Burlington Development Review Board

MEMORANDUM

TO: Development Review Board
FROM: Kirk Dressing, Associate Planner
DATE: June 2, 2026
RE: ZP-26-167; 355 Ethan Allen Parkway

Request: Proposed amendment to the Planned Unit Development (PUD) approved under ZP-25-517. The three 2-unit additions will change to three 2-unit detached buildings.

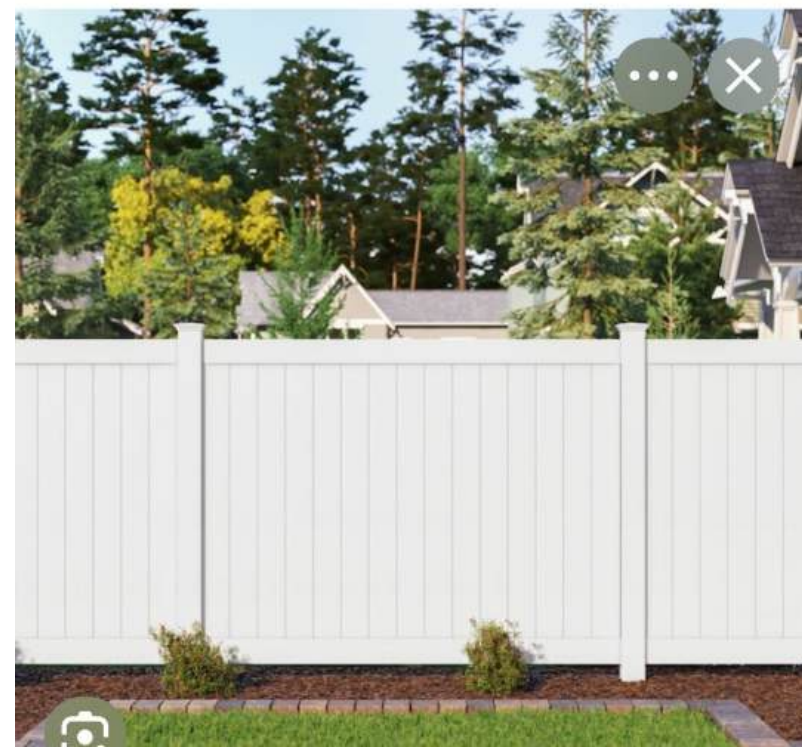
With 6 new dwelling units, 2 short term spaces will be needed (i.e. a bike rack), and 6 long term spaces will be needed (i.e. covered within a garage, shed, or within the dwelling units).
Scott Gustin 10/21/25

LIGHTING PLAN

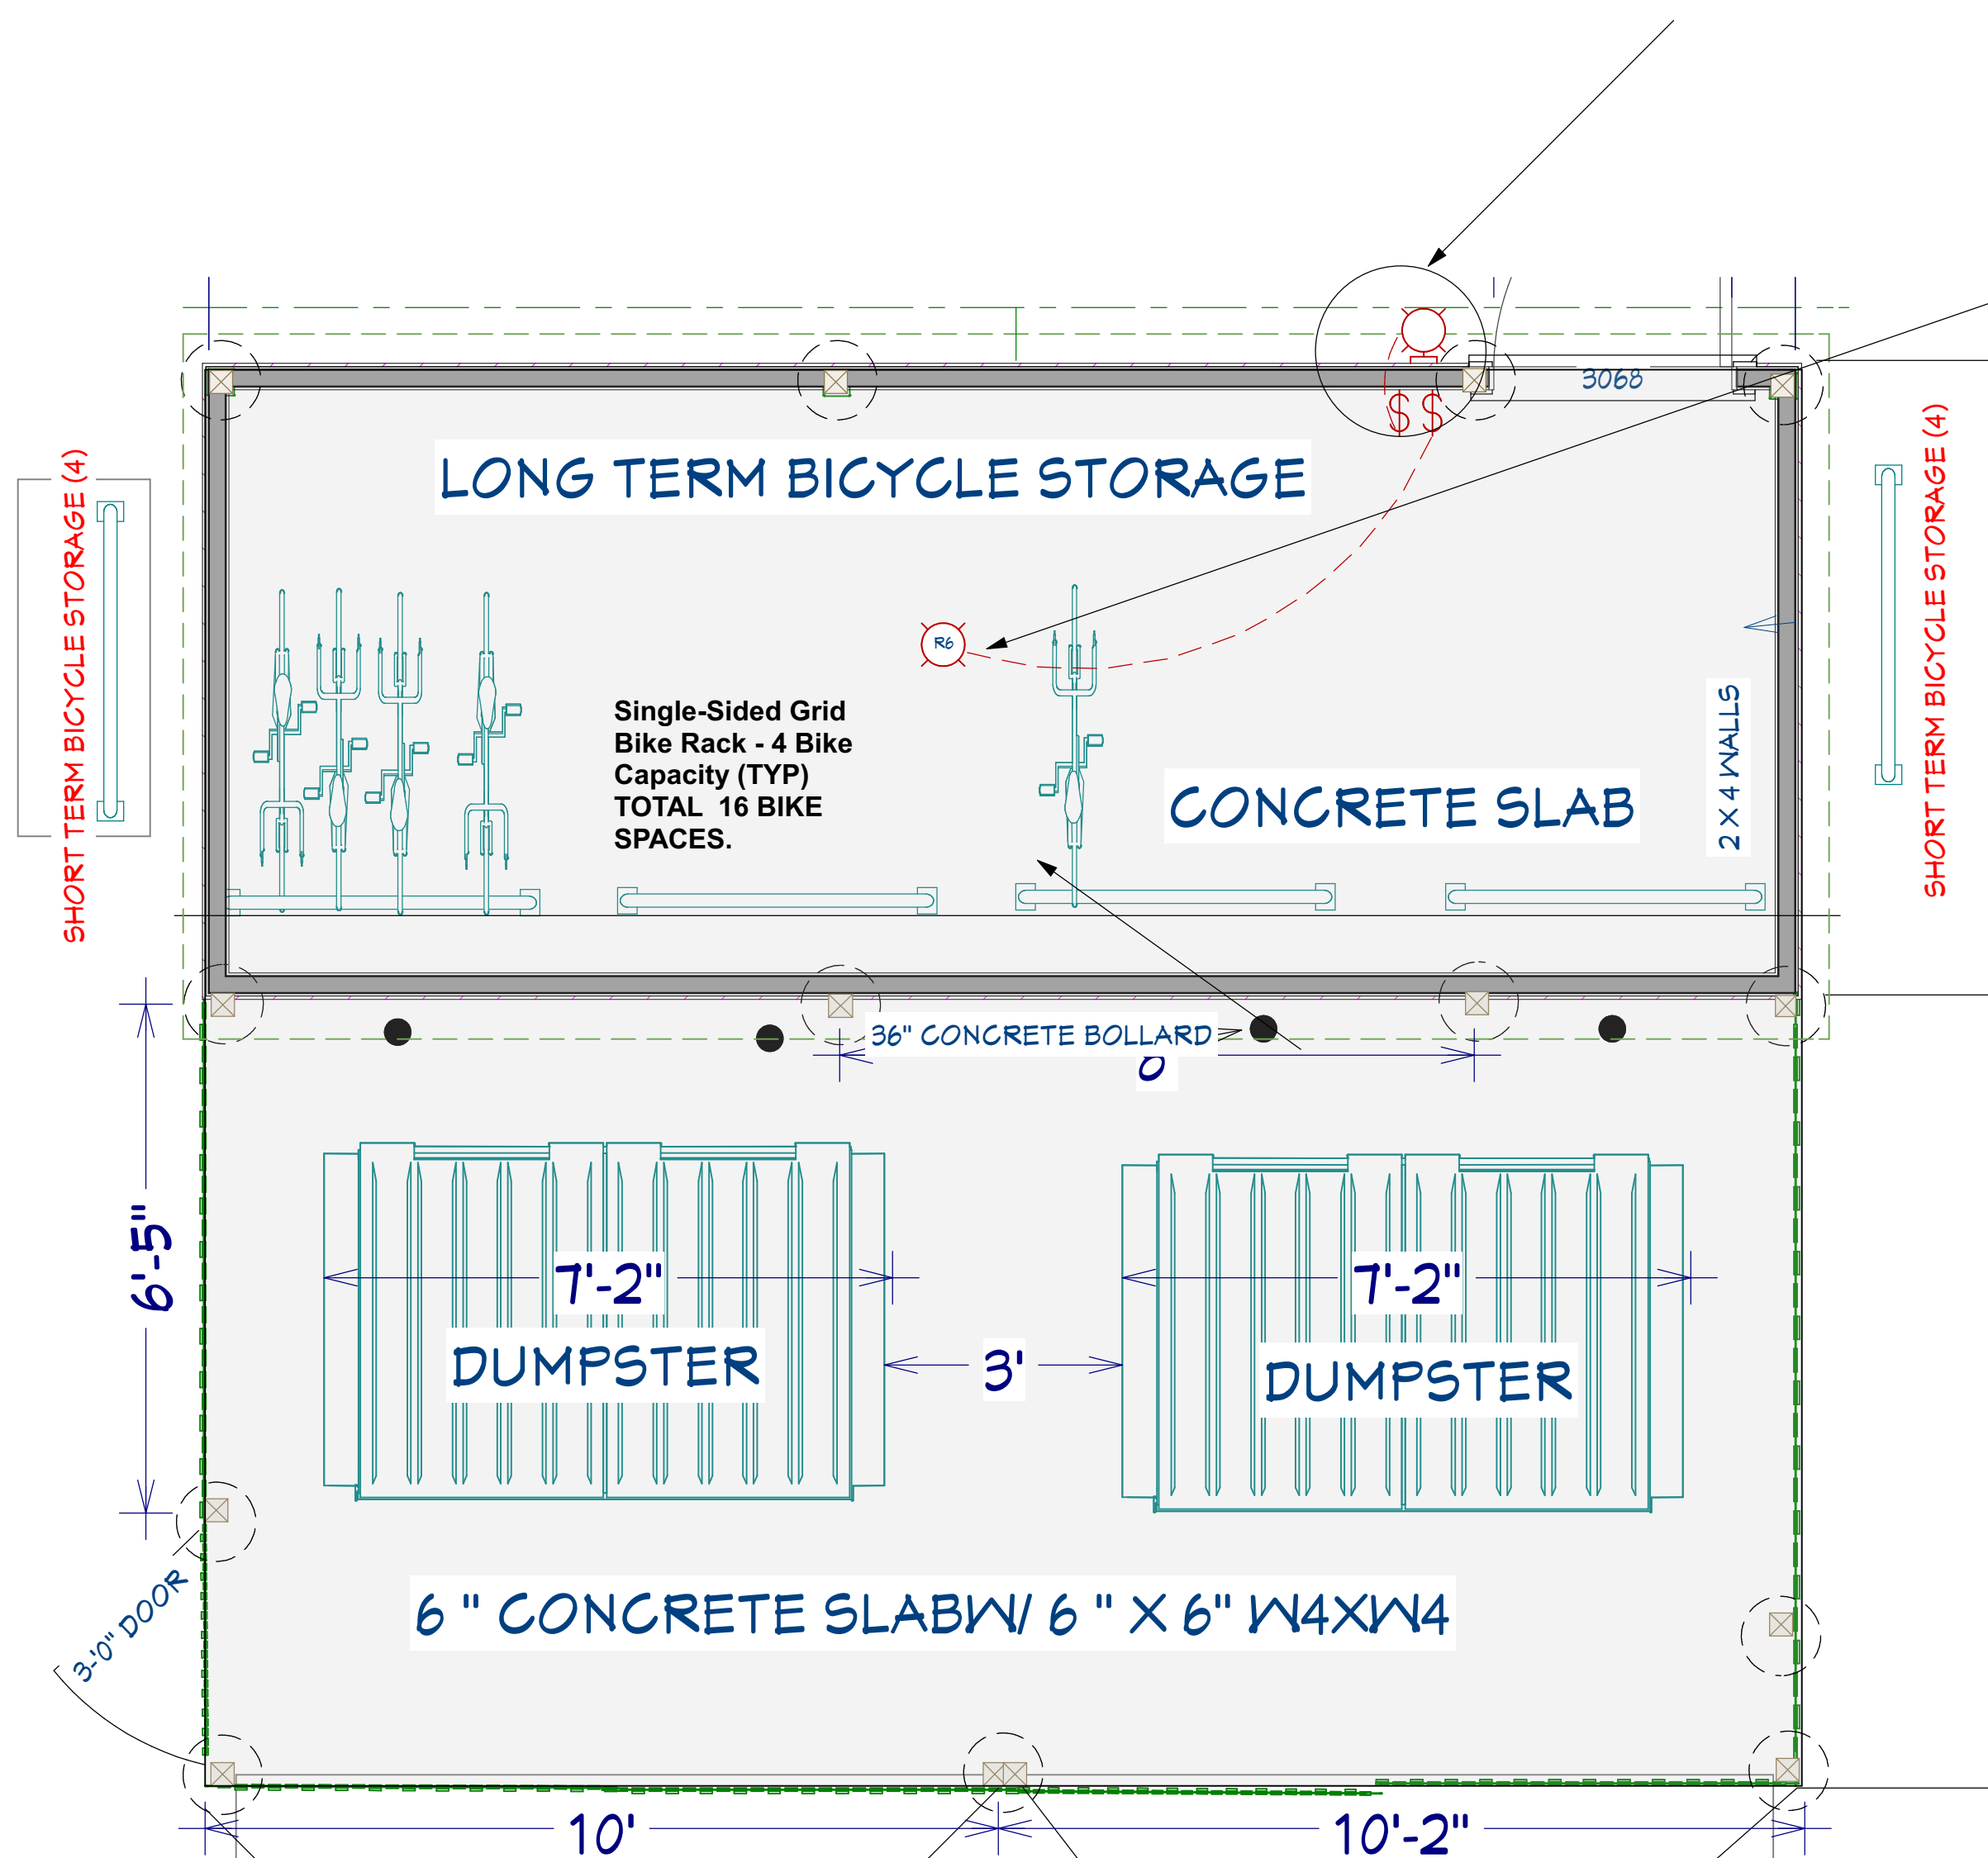
The application materials include a basic lighting plan showing the model and location of proposed lighting. The only outdoor lighting proposed is a wall sconce to be placed next to the shared bicycle storage entrance. Based on the model number provided by the applicant, the proposed outdoor fixture has an output of 1,105 lumens which qualifies as low output.

EXISTING TREES TO REMAIN

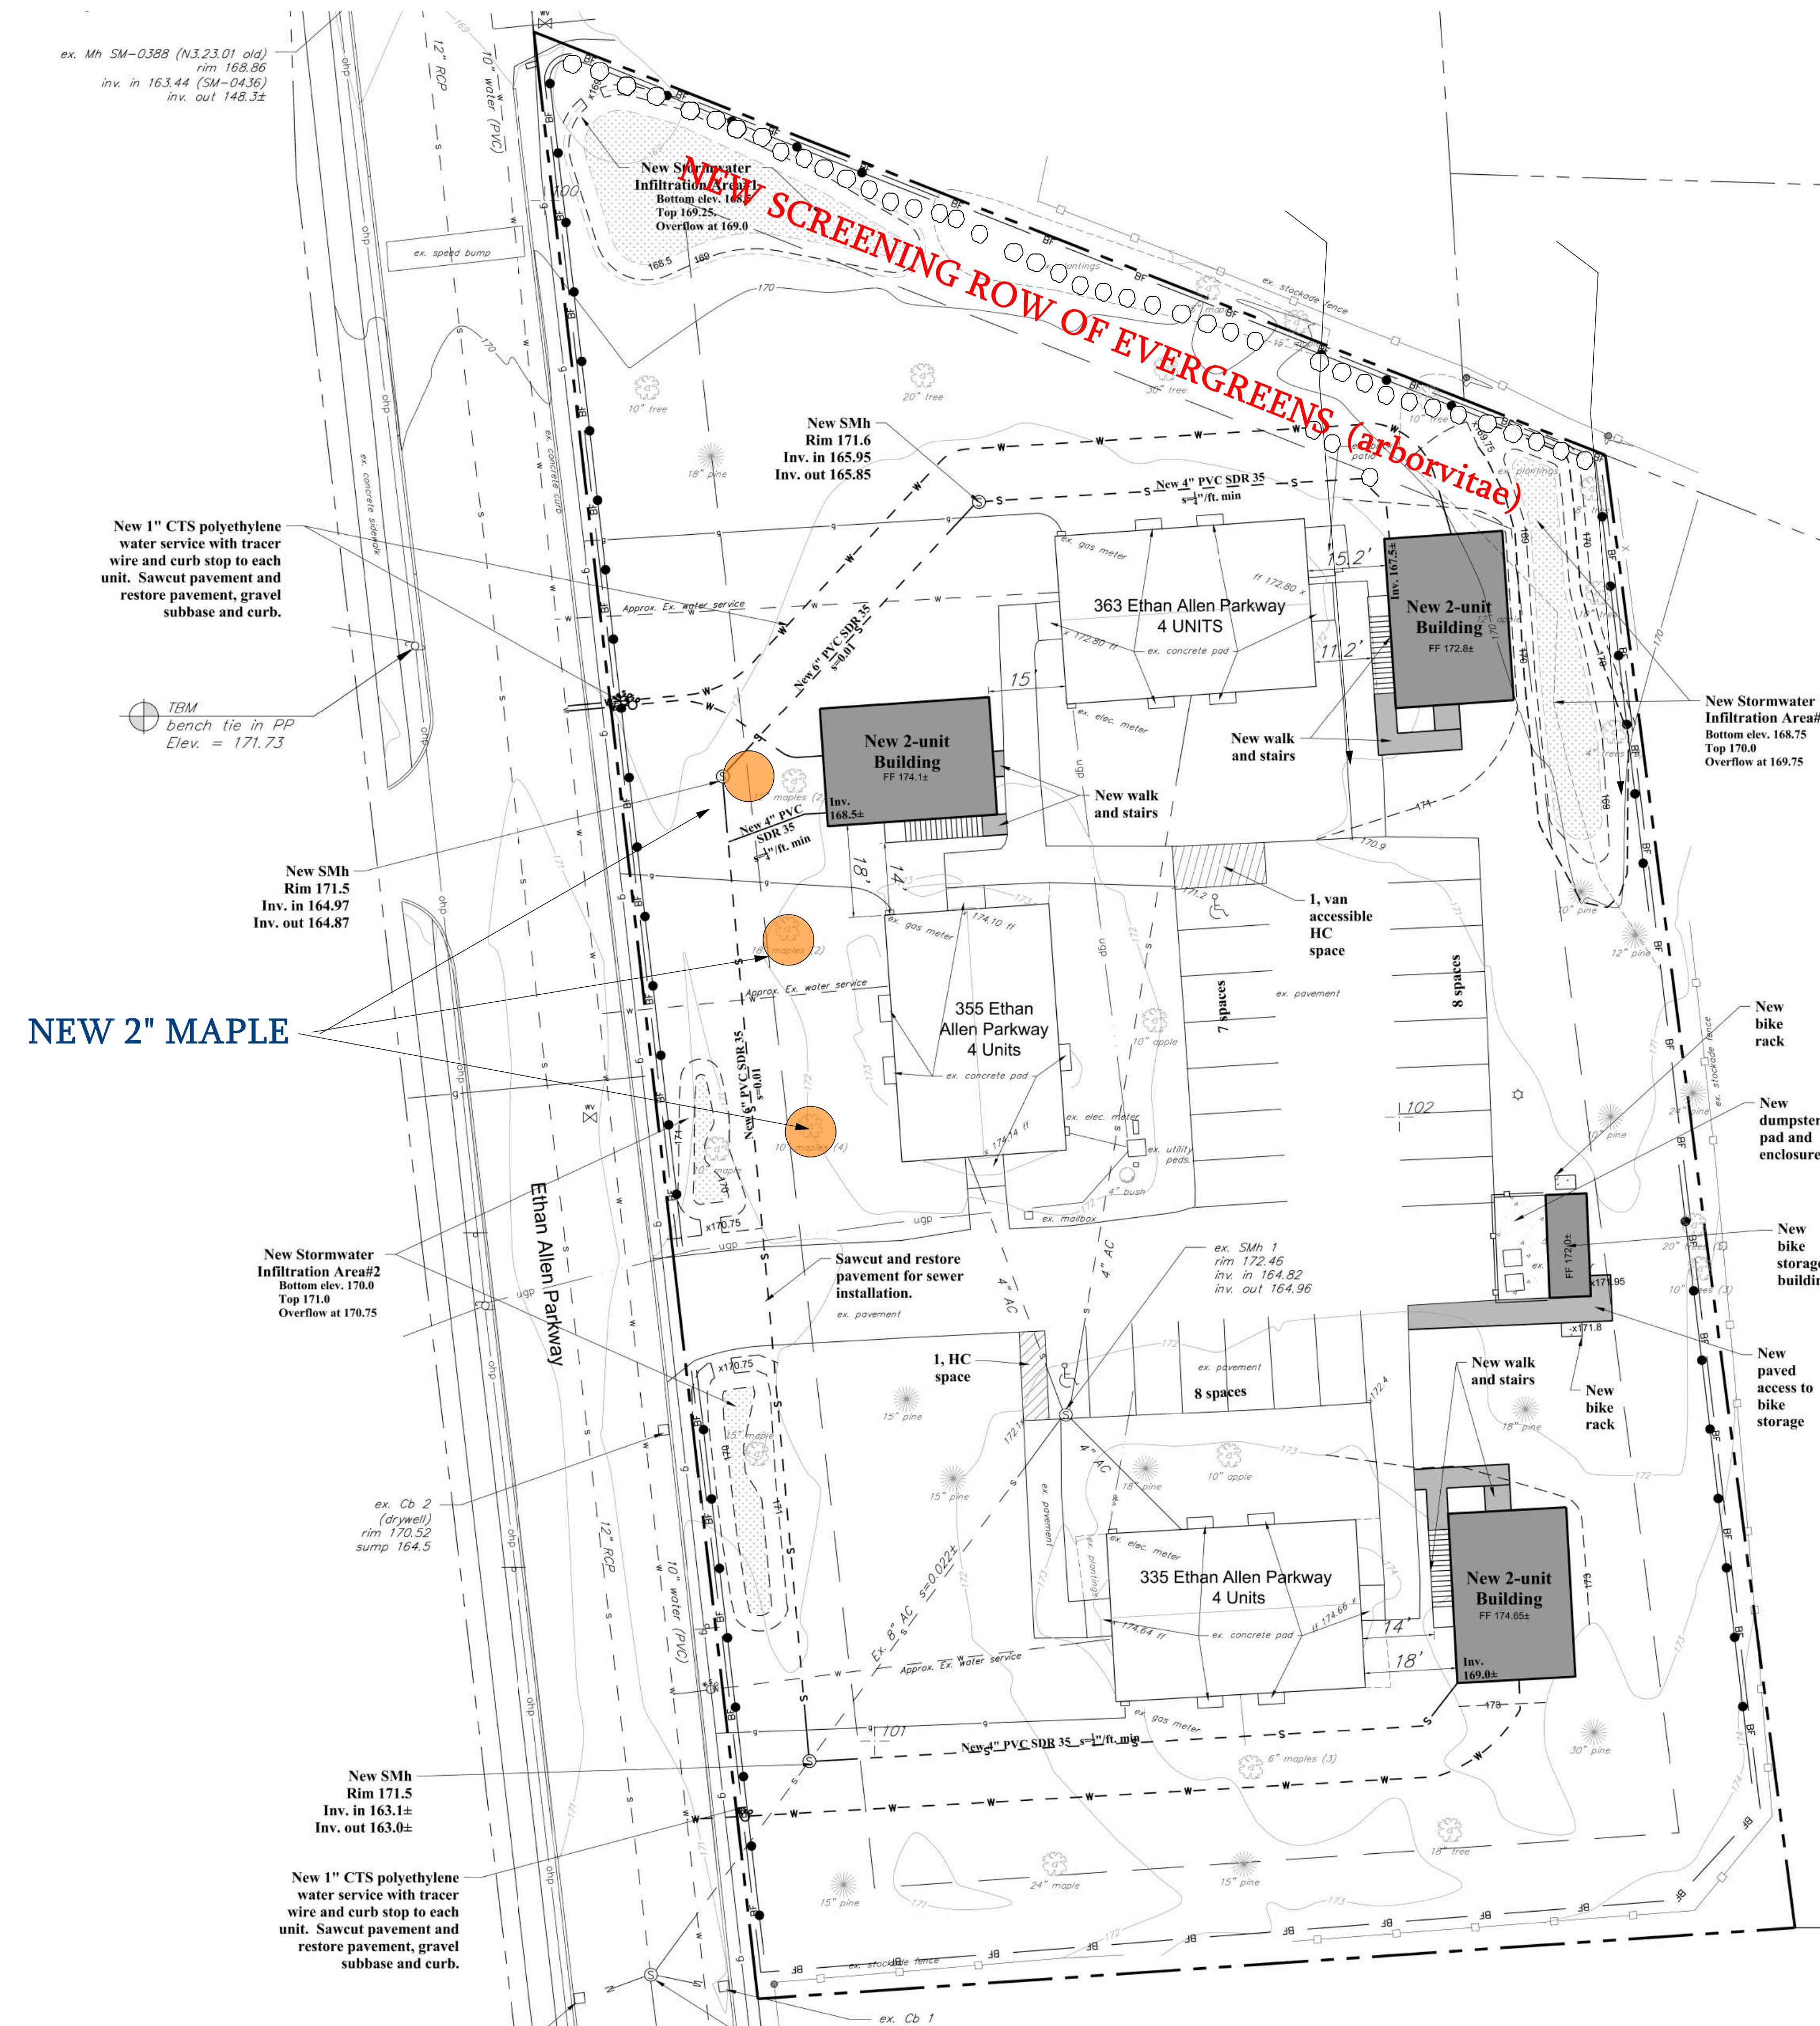
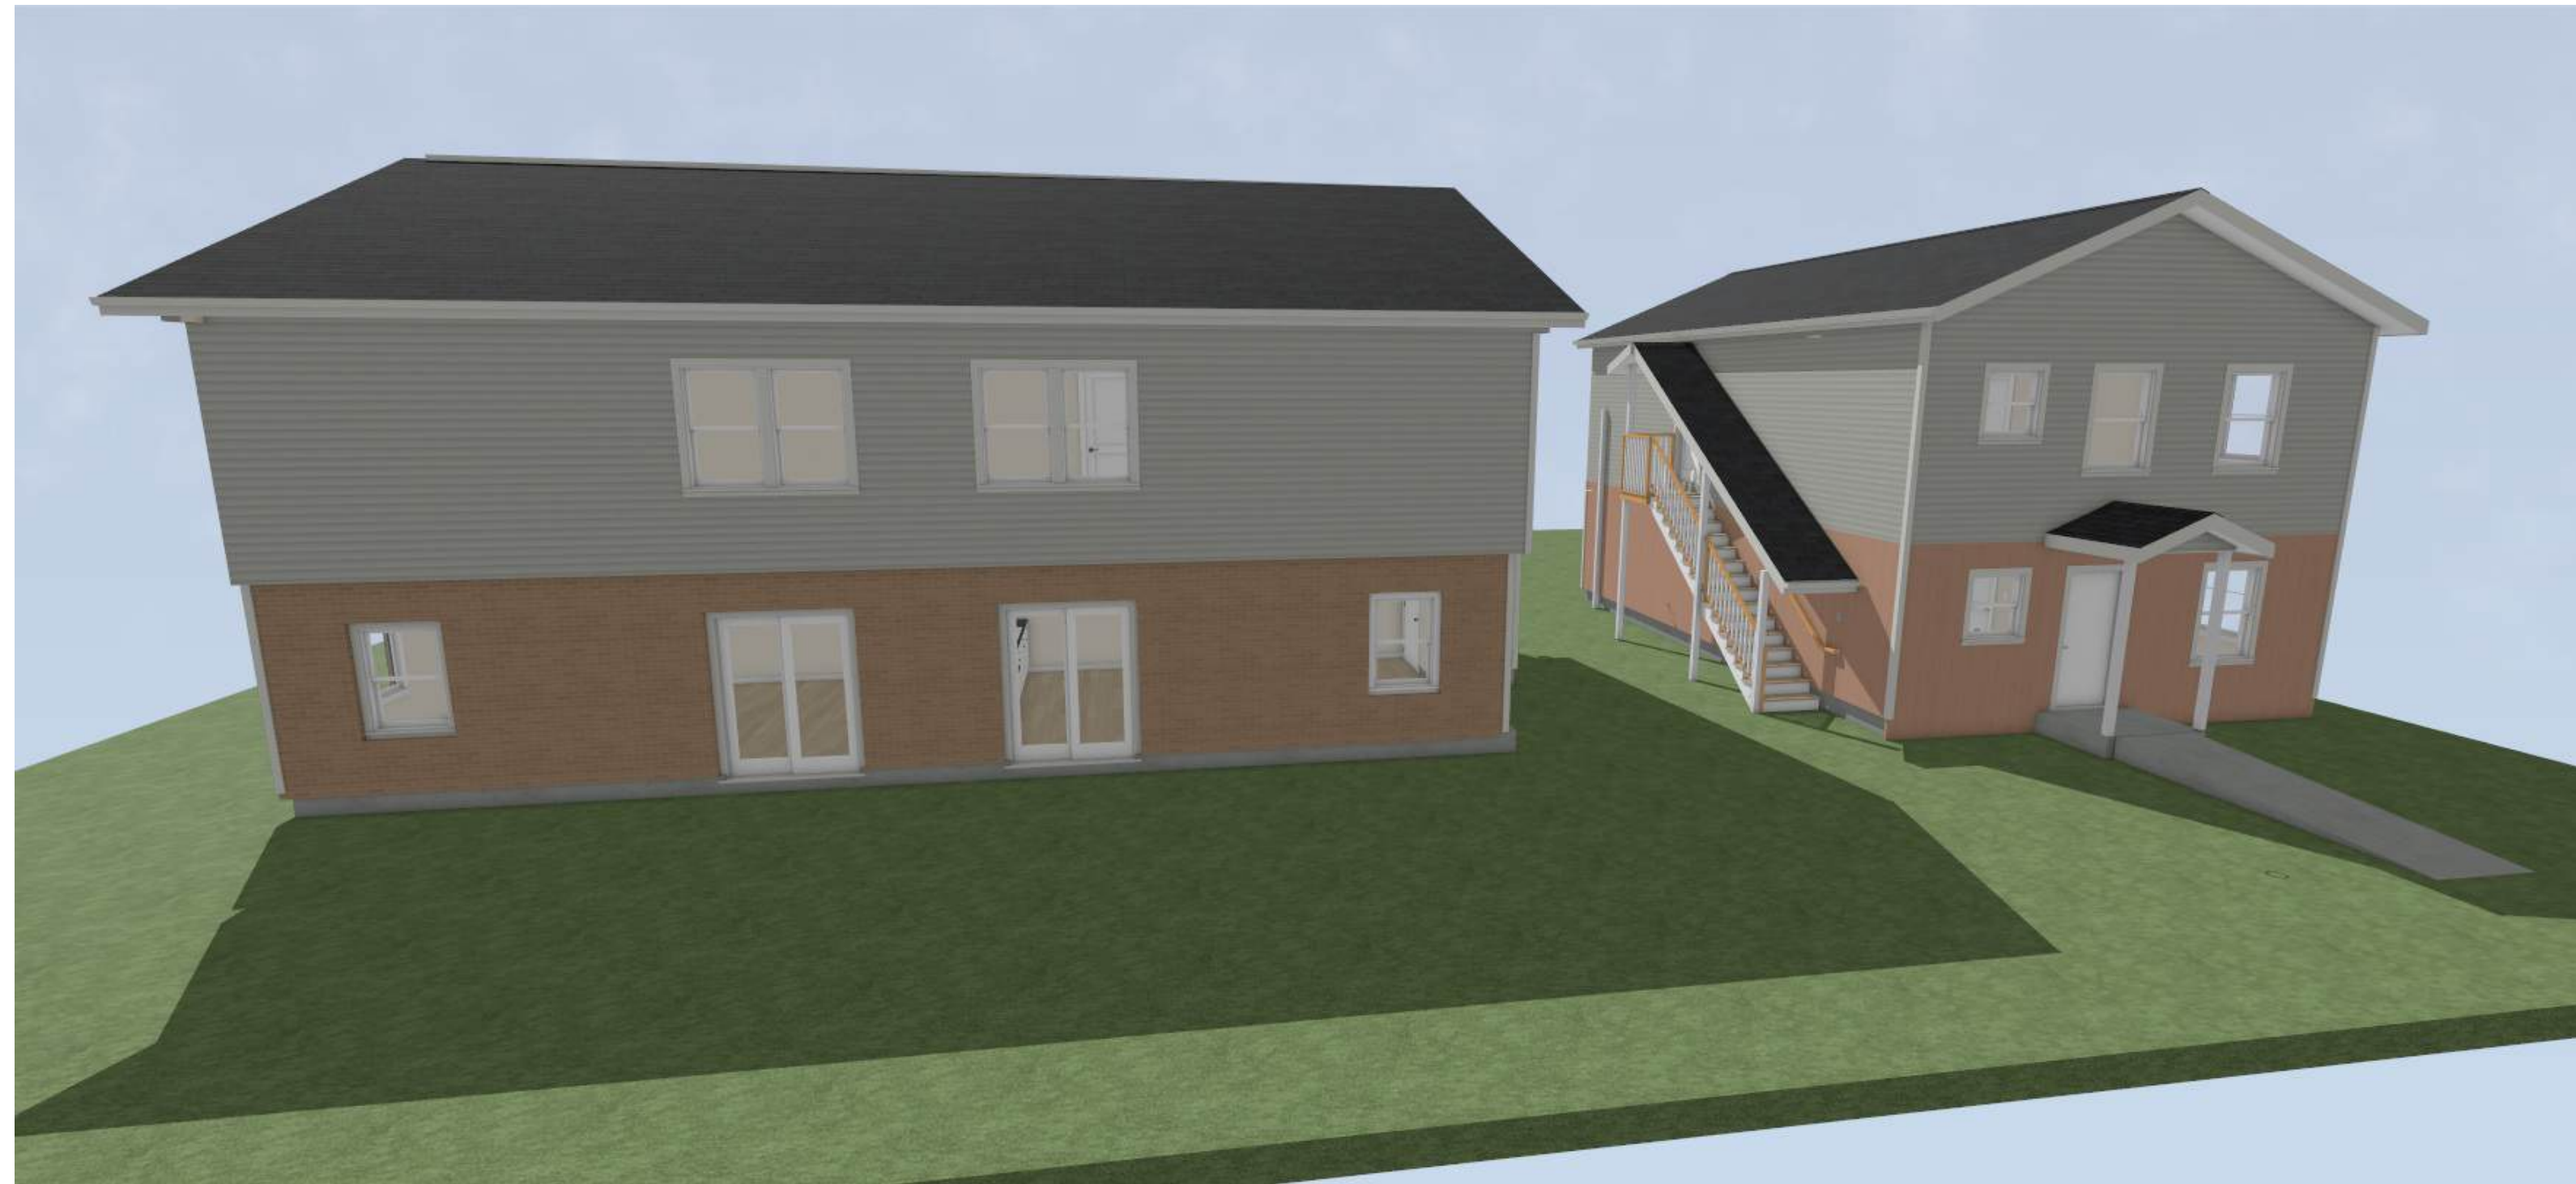
Submitted landscaping plans show three maple trees are proposed on the site as well as a row of arborvitae along the northern boundary line per previous DRB conditions. Landscaping plan also identifies existing trees on property, and no trees are labeled as proposed to be removed. **(Affirmative finding)**
